**Re: Ohio Valley Electric Corporation
Kyger Creek Station's 2018 Annual Landfill Inspection**

**Reference: 2018 CCR Rule Inspection
Annual Landfill Inspection
Kyger Creek Generating Station
Cheshire, Ohio**

**2018 CCR Rule Inspection
Kyger Creek Landfill**

Kyger Creek Generating Station
Cheshire, Ohio
Gallia County

Figure No. **1**
 Title: **2018 Annual CCR Landfill Inspection**

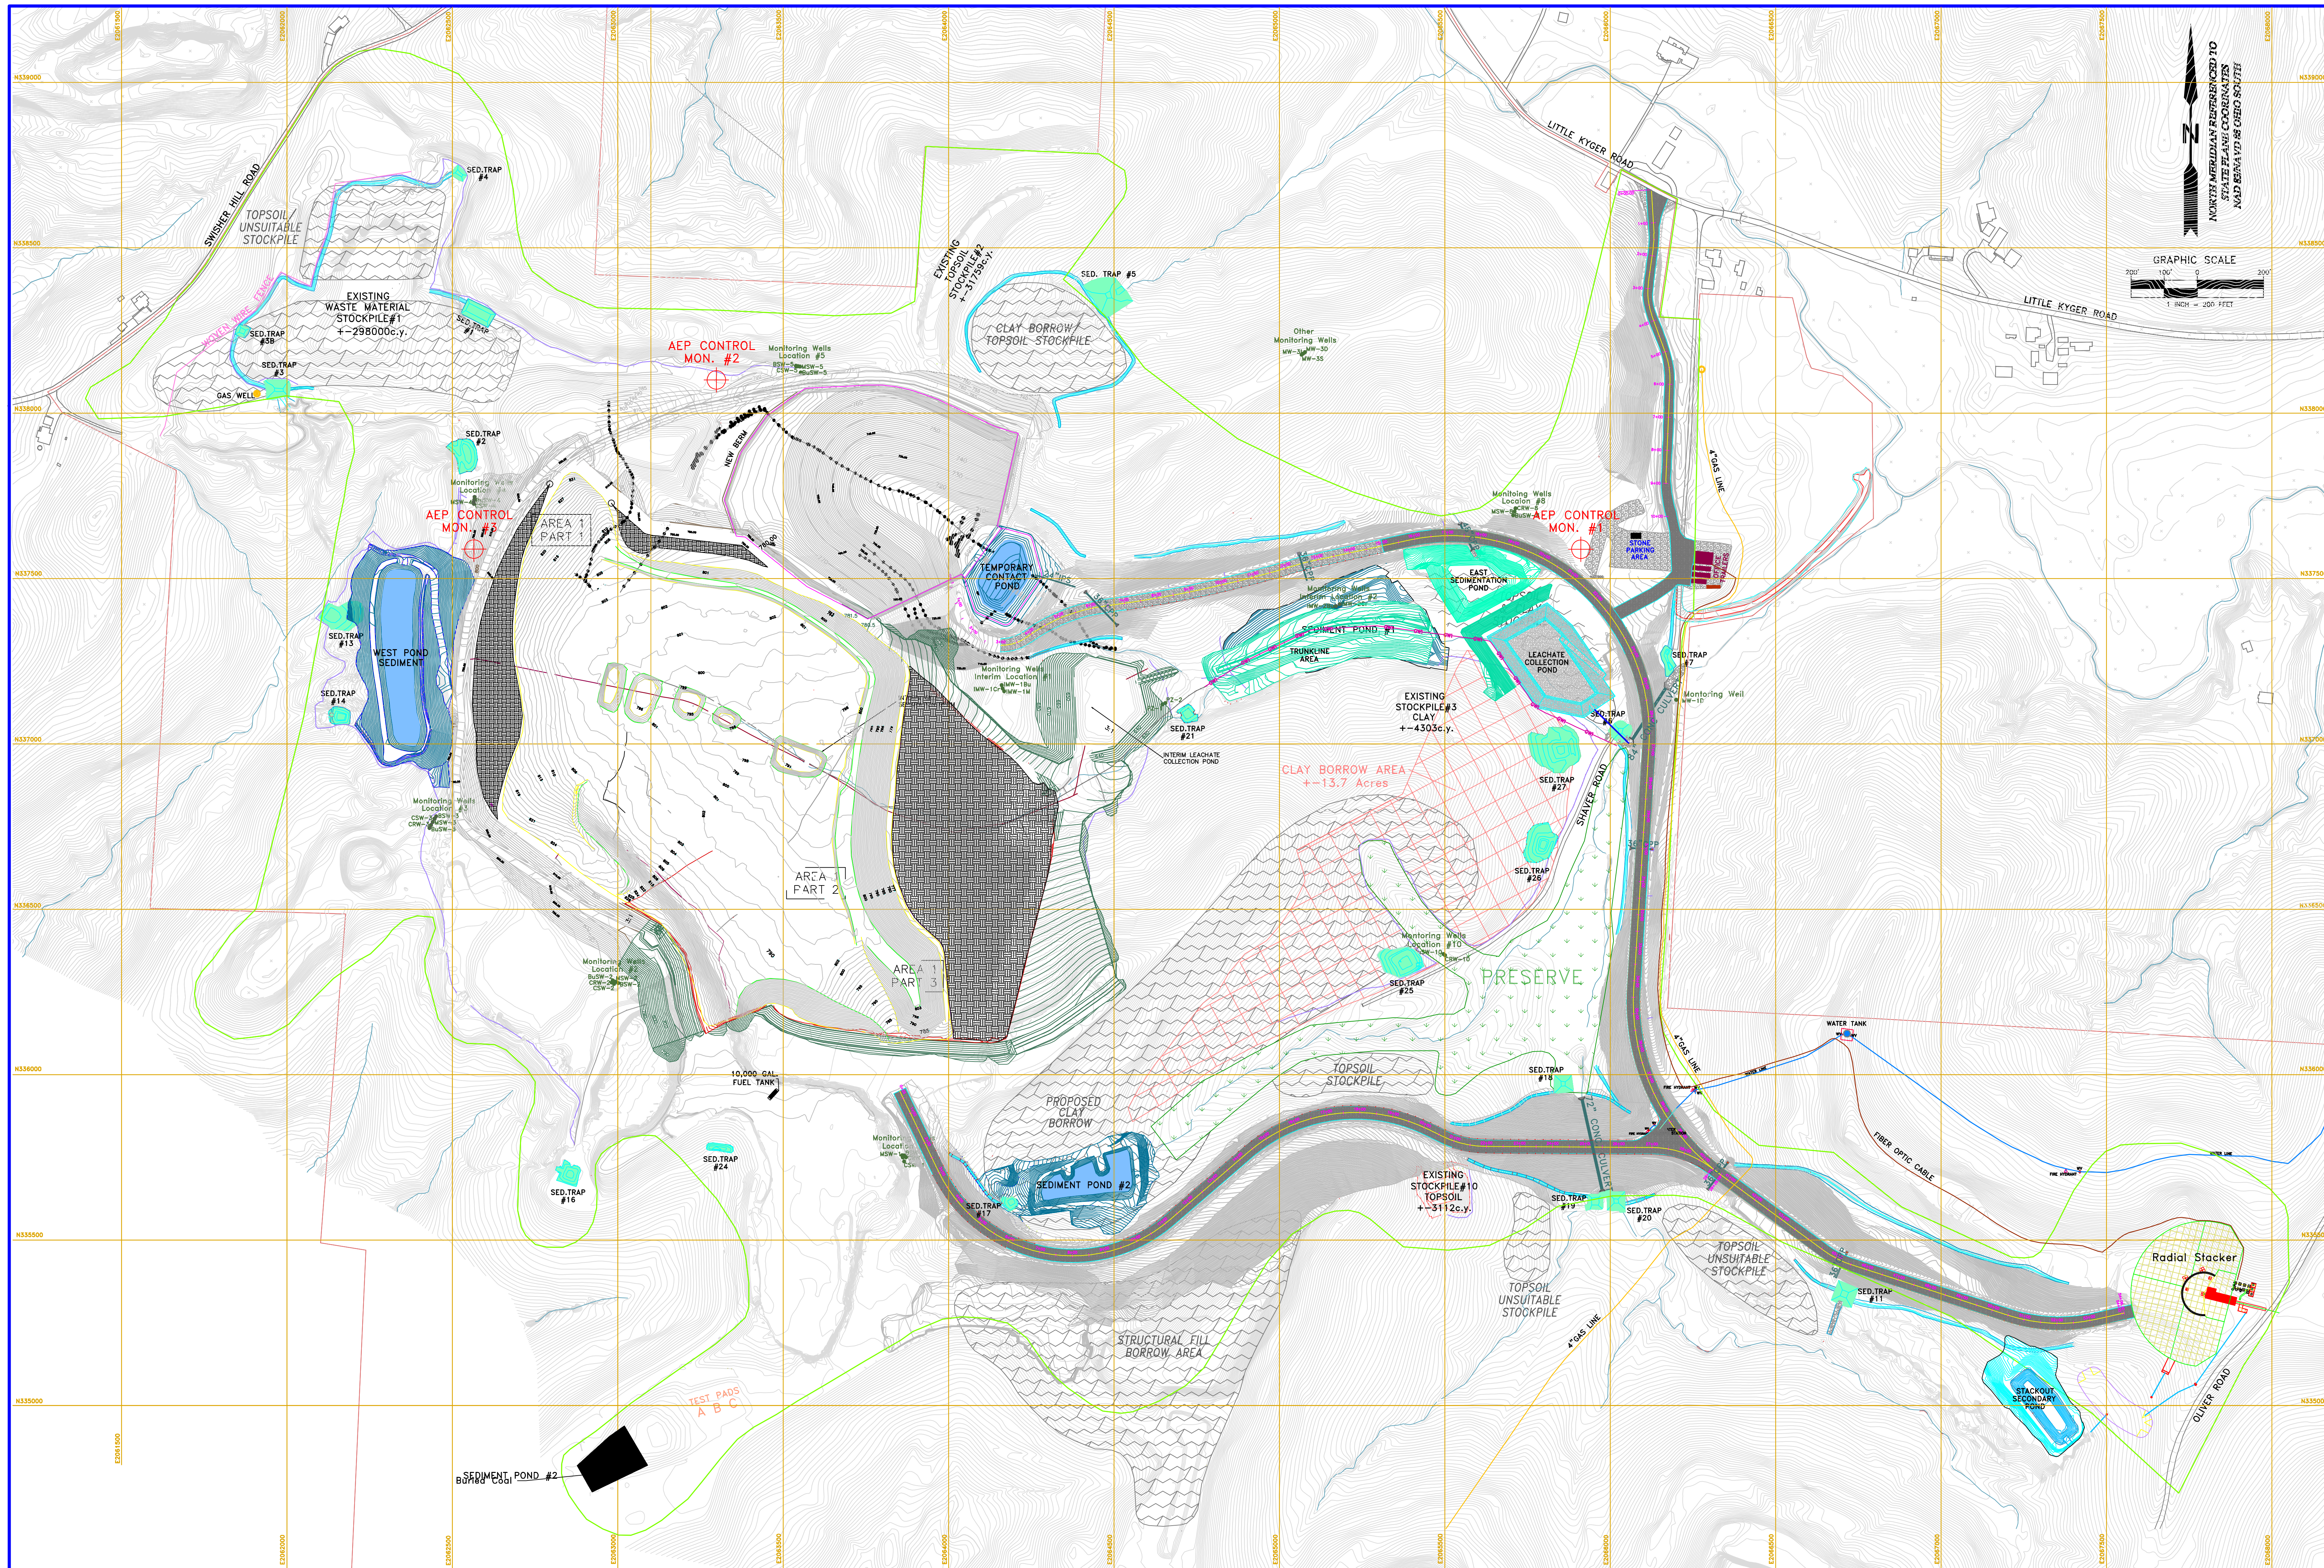
The following observations were made while walking within and around the active Phase 1 landfill footprint. Appendix A includes an aerial of the active landfill with GPS-located points. The photographic log is provided in Appendix B.

- The vegetation between Phases 1 and 2 is thin with bare earthen areas near the phase boundary. (Photo 4, Appendix B). The plant appears to be revegetating the area with zones of new vegetation noted (Photo 5, Appendix A; Point 1, Appendix B).

- The Phase 1/Phase 2 separation/transition berm is visible in only a few areas. As waste placement comes up in Phase 1, it is tying into the separation/transition berm in several locations. The CCRs were not noted downhill of the berm in the Phase 2 area adjacent to the active cell (Photo 6, Appendix A; Point 2, Appendix B).

- Small diameter trees and taller vegetation (12 to 48 inches) remain on the western slope of Phase 1 above the West Sedimentation Pond. Heavy vegetation obscures clearer measurement of the conditions. This region is identified in red on the figure (red region, Appendix A; Photo 10, Appendix B). In 2017, field observations suggest multiple sloughs in this area, including a progressive slough with a 3-foot head scarp and a width of 38 feet located approximately 10 feet from the road elevation and a second smaller scarp located north of it.

- Five 24-inch high-density polyethylene (HDPE) pipes underlie the access road west of Phase 1. The pipes outlet into a riprap-lined channel that flows to the West Sedimentation Pond. The pipe inlets are partially blocked due to soil erosion of the road and Phase 1 temporary cover. The roadway above the pipe outlets is heavily eroded (Points 4 and 5, Appendix A; Photos 11 and 12, Appendix B).

- On the western slope of Phase 1, a three-inch inner-diameter plastic pipe have been crushed (Point 6, Appendix A).
- The eastern temporary slope of Phase 1 shows erosion rills near the toe. The zone is vegetated and mowed. Sediment has built up in the pond at the toe of slope with the overflow structure unrestricted but near capacity. The slope is approximately 2.9H:1V (Point 7, Appendix A; Photos 13 and 14, Appendix B).

- At the northern edge of the eastern Phase 1 face, an erosion hole and gully have formed near the transition from Phase 1 to Phase 2. The erosion hole is approximately four feet by two feet. Two points are noted for the top and toe of the gully (Points 8 and 9, Appendix A; Photos 15 and 16, Appendix B).

- The area beyond the eastern edge of the active Phase 1 cell remains spongy with clear seepage flowing eastward (Points 10 and 11, Appendix A; Photos 17, 18, and 19, Appendix B).

- Deep erosion gullies were noted on the western and southern interior slopes of the Interim Leachate Collection Pond. Gullies measured one to three feet wide with depths up to 2.5 feet (Points 12 through 15 (area denoted by the navy line), Appendix A; Photos 23 and 24, Appendix B). Taller vegetation obscures visual observation along the crest of the dike.

- A wet earth zone lies at the toe of proposed Phase 2 slope along the western side of the Interim Leachate Collection Pond crest (Photo 25, Appendix B).
- The access road to the Interim Leachate Collection Pond has a deepening gully (Point 16, Appendix A).

- An erosion gully approximately 3.5-feet wide by 18-inches deep is present on the north side of the access road to the West Sedimentation Pond (Point 17, Appendix A; Photo 26, Appendix B).

- Sediment is infilling the stormwater channel at the toe of the access road to the West Sedimentation Pond (Point 18, Appendix A; Photo 27, Appendix B).

- A low spot is present in the pond's overflow structure. Standing water is present on the northeastern portion of the structure (Point 19, Appendix A; Photo 28, Appendix B).

- A progressive scarp has formed on the northwestern exterior slope of the West Sedimentation Pond. The head of the scarp measures 18 inches to two feet in height with 30-percent of the pond's crest width affected (Point 20, Appendix A; Photos 29 and 30, Appendix B). The crest feels spongy. The zone measures approximately 30 feet wide parallel to the crest of the pond and extends to 20 feet from the downhill channel.

- Small scarps (6 to 24 inches in depth) were noted uphill of Sediment Trap No. 13 (Point 21, Appendix A).
- Two light sediment piles, approximately 14 feet in diameter, were observed. One was at the south end of the pond. The other was at the northern end (Points 22 and 23, Appendix A; Photo 31, Appendix B).

- The crest of the southeastern dike for the East Sedimentation Pond has standing water and rutting (Points 24 and 25, Appendix A; Photo 32, Appendix B). Vegetation is approximately 12 to 18 inches high.

- A slough approximately 4-feet high and 20-feet wide was noted on the northwest interior slope above the concrete slope. This is the shared dike with the East Sedimentation Pond. This appears unchanged from the 2017 inspection report (Point 26, Appendix A; Photos 32 and 33, Appendix B).

- Wet zone at northeast corner on the pond's concrete liner (Photo 34, Appendix B).
- A seepage zone was observed along the southwestern edge of the Leachate Collection Pond. Flow through concrete joints within the pond was noted, and a wet region of the earthen embankment was noted (Points 27 and 28, Appendix A; Photos 34 and 35, Appendix B).

- A discolored sheen was visible on the northwestern side of Sediment. Trap No. 6 southwest of the Leachate Collection Pond (Point 29, Appendix A; Photo 36, Appendix B).

- Mow the vegetation along the western edge of Phase 1 above the West Sedimentation Pond to understand potential stability concerns in this area. Characterize and remediate the sloughs as needed.

- Maintain the vegetation along the interior and exterior slopes of the Interim Leachate Collection Pond. Redress the interior gullies as need, and characterize the slough on the southern side.
- Characterize and address the seepage occurring near the underdrain pipe at the east side of Phase 1. Take measures to control the flow, minimize sediment transport, and review the design to verify that it is performing as designed. Continue to monitor the toe of the active waste slope.

- Relocate the Phase 1/Phase 2 separation/transition berm. Maintain the toe of the active waste limit as shown in the construction drawings to allow contact stormwater management within the facility. CCRs outside of the berm were not observed during this field visit.

- Remove the sediment restricting flow through the five HDPE pipes flowing from the Phase 1 western slope to the West Sedimentation Pond. Repair and maintain the stormwater best management practices (BMPs) for the channels flowing to the pipes. Remediate the eroded area at the pipe outlets to protect the access road for Phase 1.
- Maintain the vegetation along the exterior slopes and within the surface drainage channels to facilitate inspections by removing taller weeds and trees as needed.
- Continue to repair erosion gullies, reestablish grass vegetation, and monitor in future inspections.
- A cover grate is recommended for the overflow pipe at the Interim Leachate Collection Pond to minimize debris carried into the pipe.
